ADDENDUM NO.5

PROJECT - ECA @ CEC Modernization, Renovation & Addition

RFP NO. 21-032 RRR
APS PROJECT # 507
NIGP Code: 90927; 90928; 909

A1 POWER FLOOR PLAN
EP101

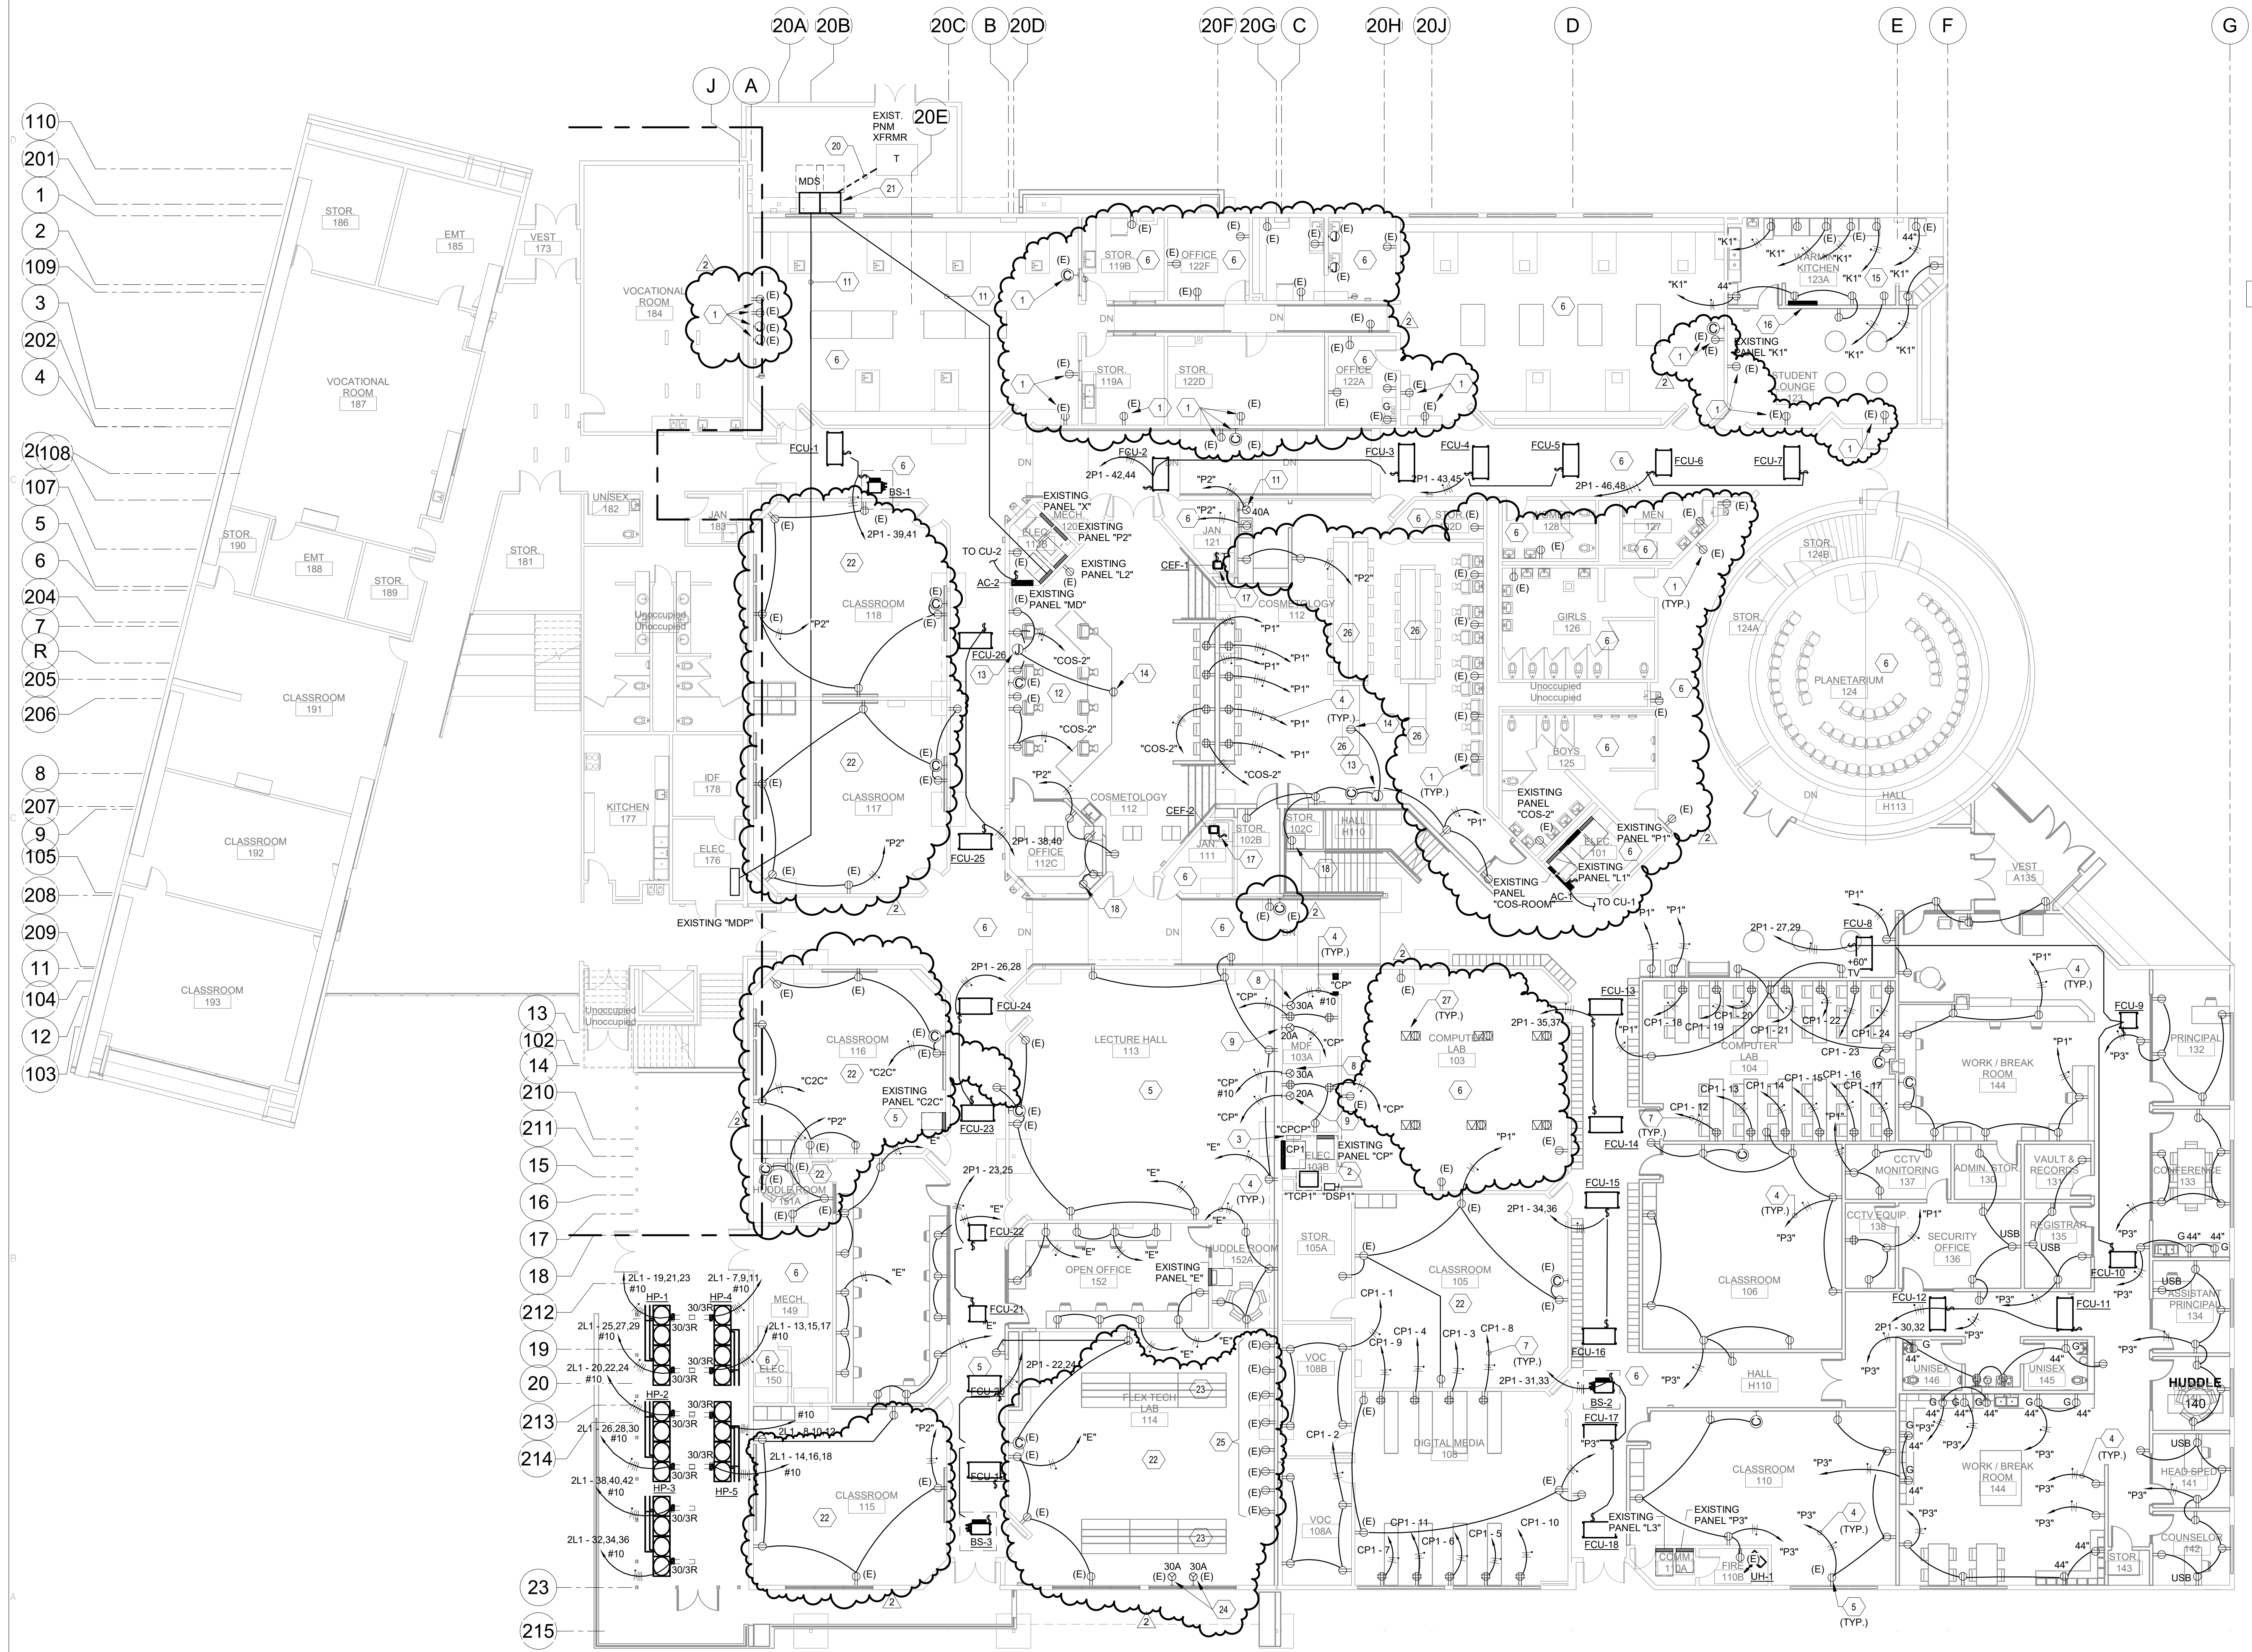
- a. ADD electrical information per attached **EXHIBIT 07** to cover recent abatement.

SPECIAL SYSTEMS FLOOR PLAN

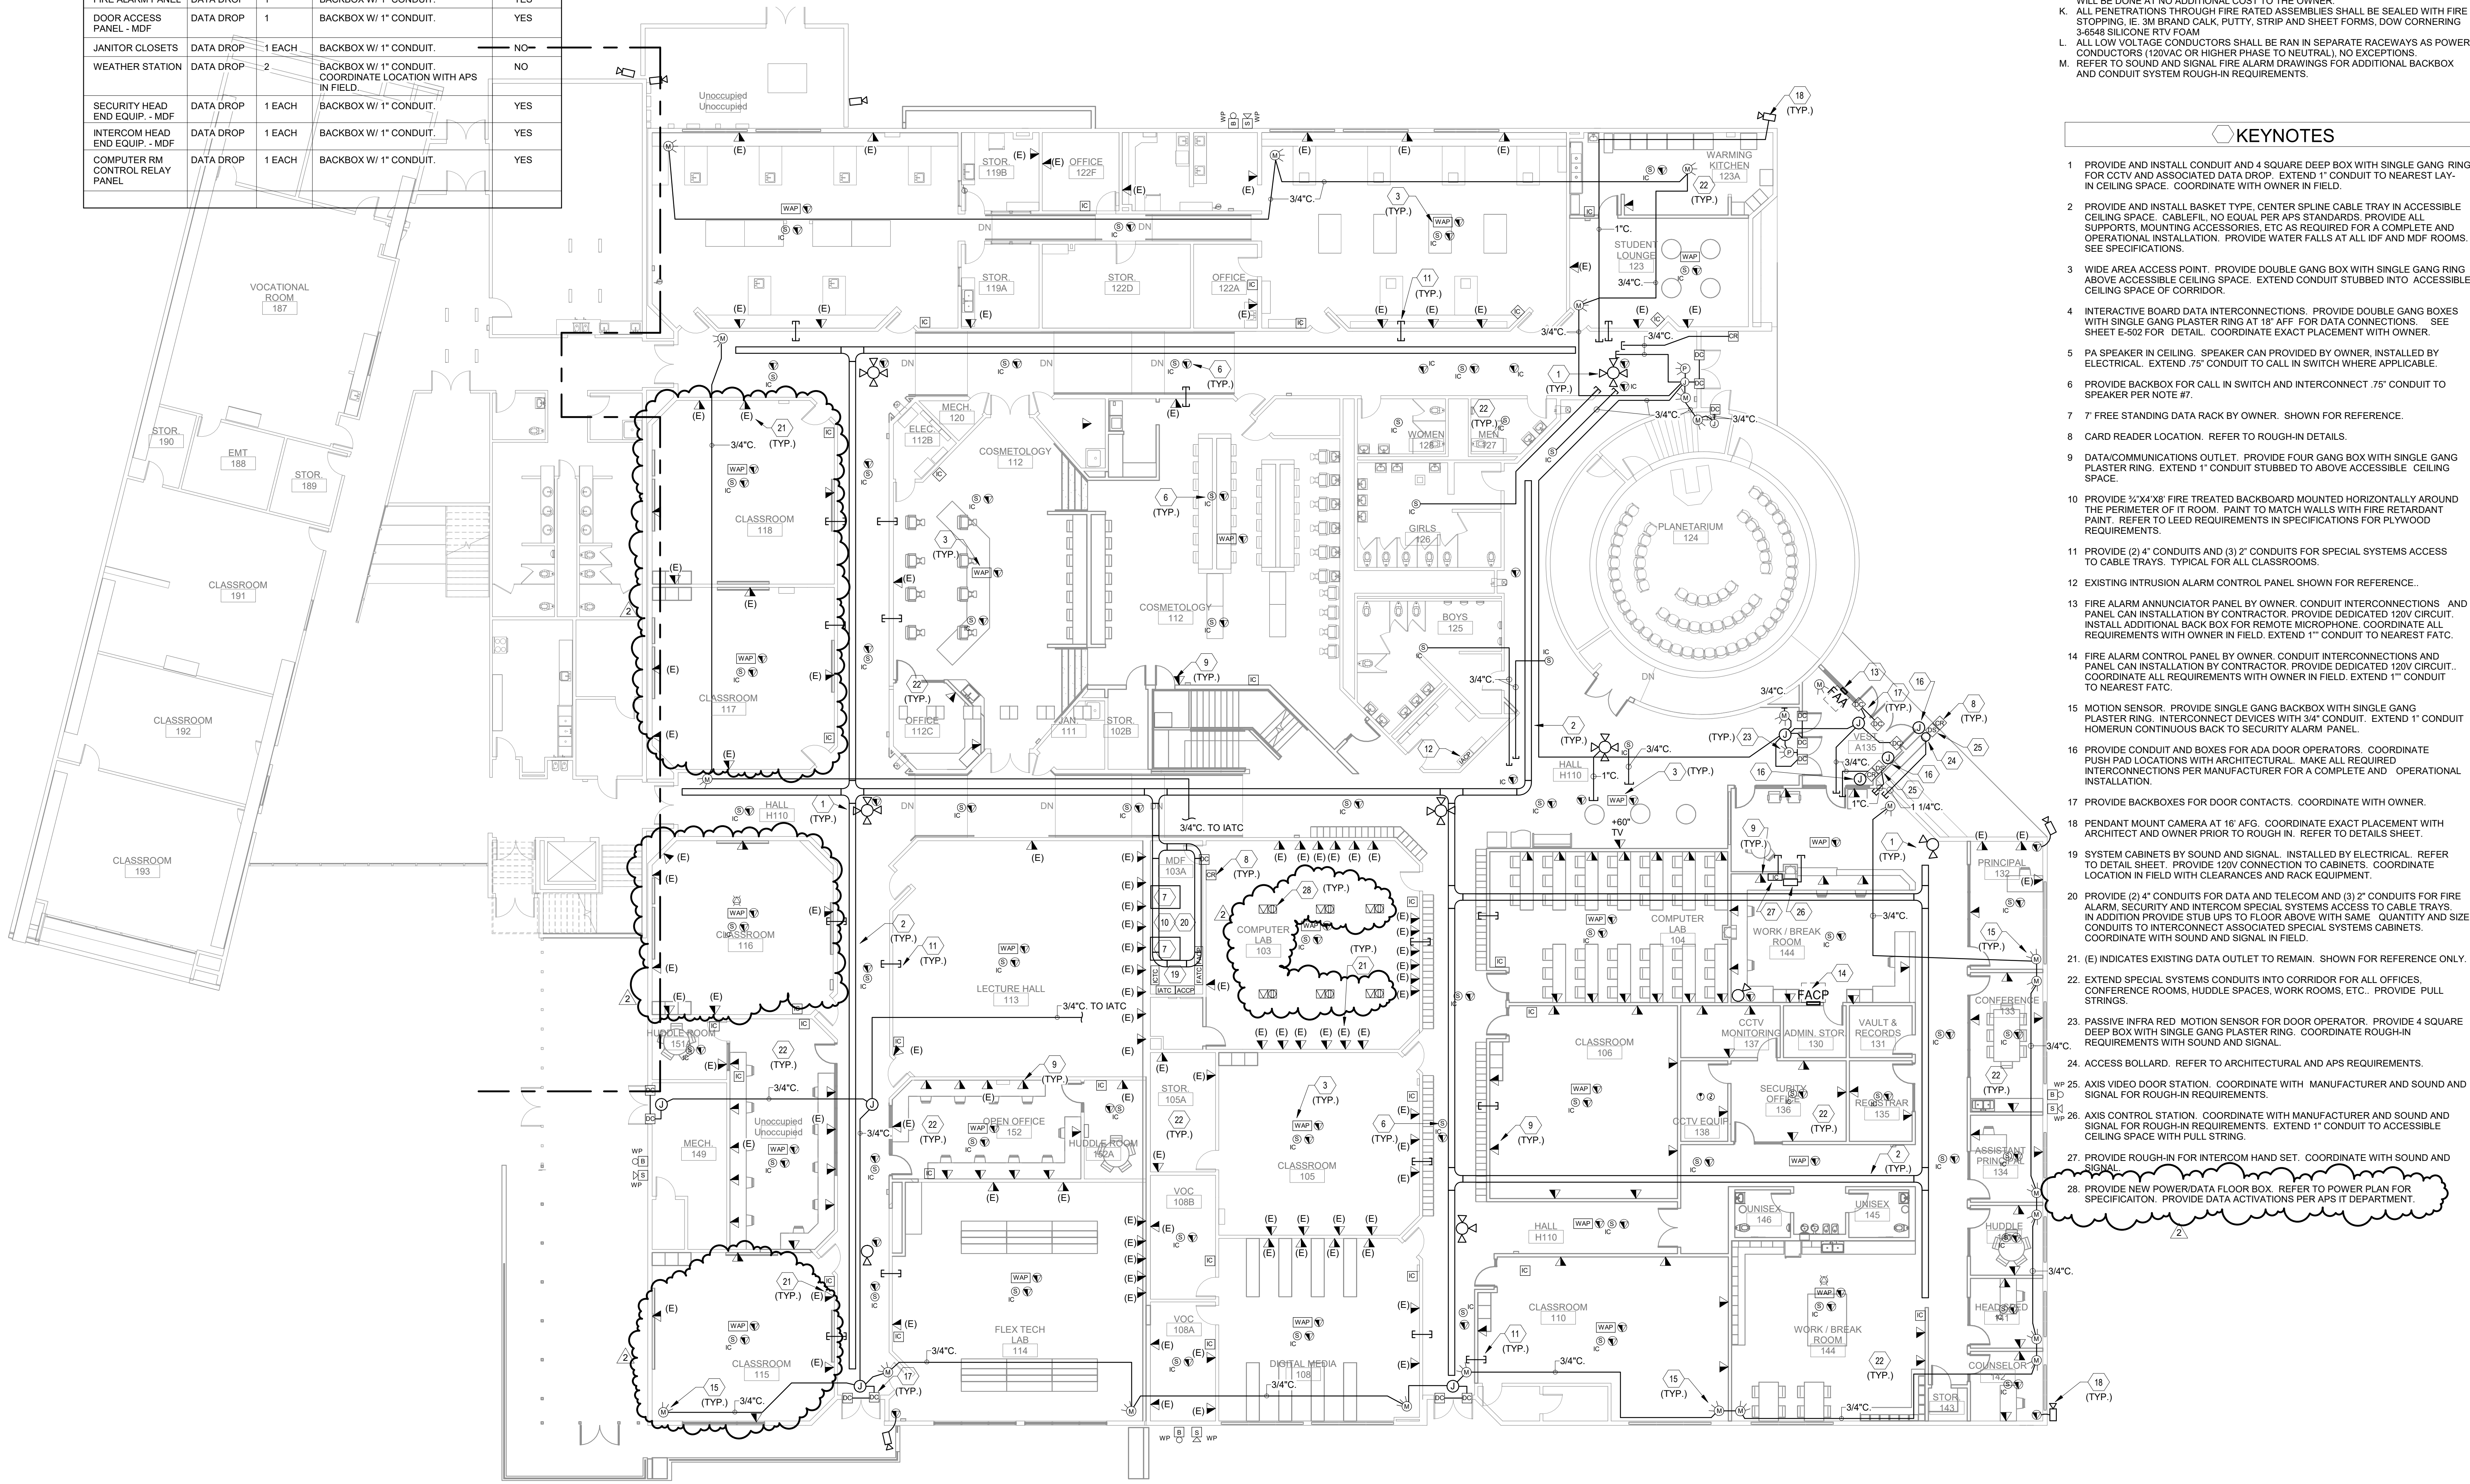
- a. ADD data information per attached **EXHIBIT 08** to cover recent abatement.
- b. CLARIFY fire alarm general notes to include Sound and Signal drawings.

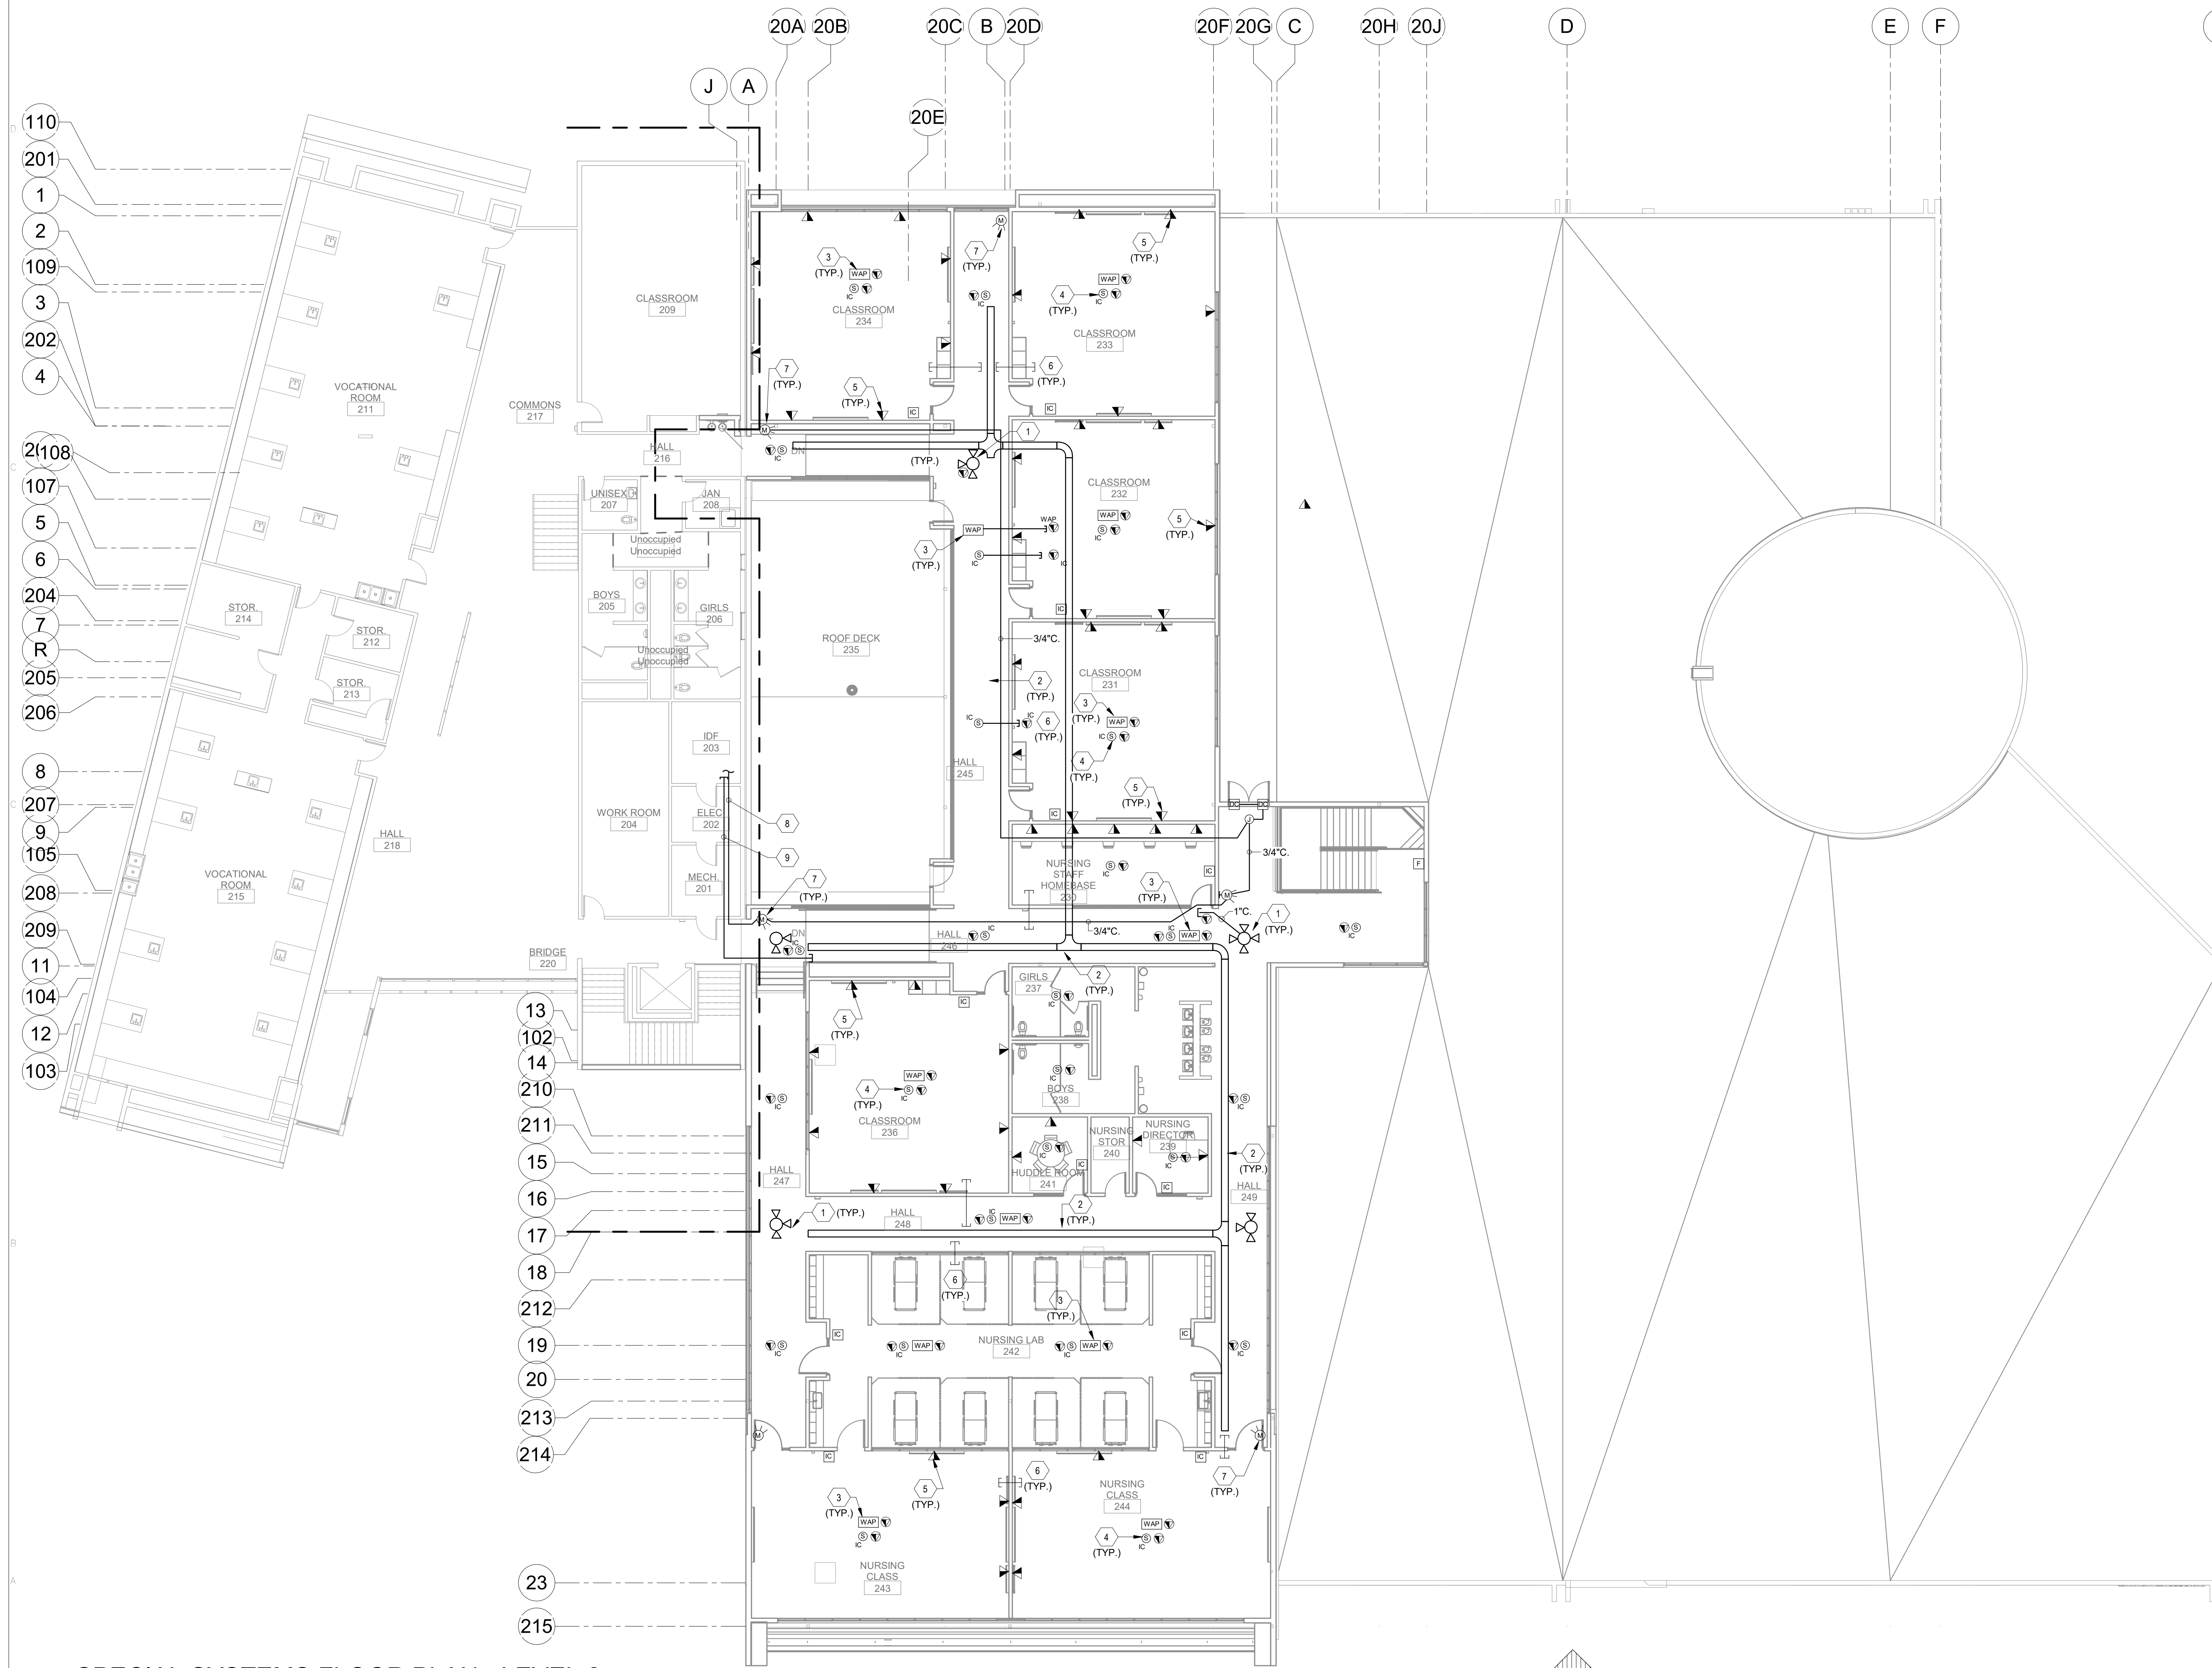
- a. CLARIFY fire alarm general notes to include Sound and Signal drawings, see attached **EXHIBIT 09**.
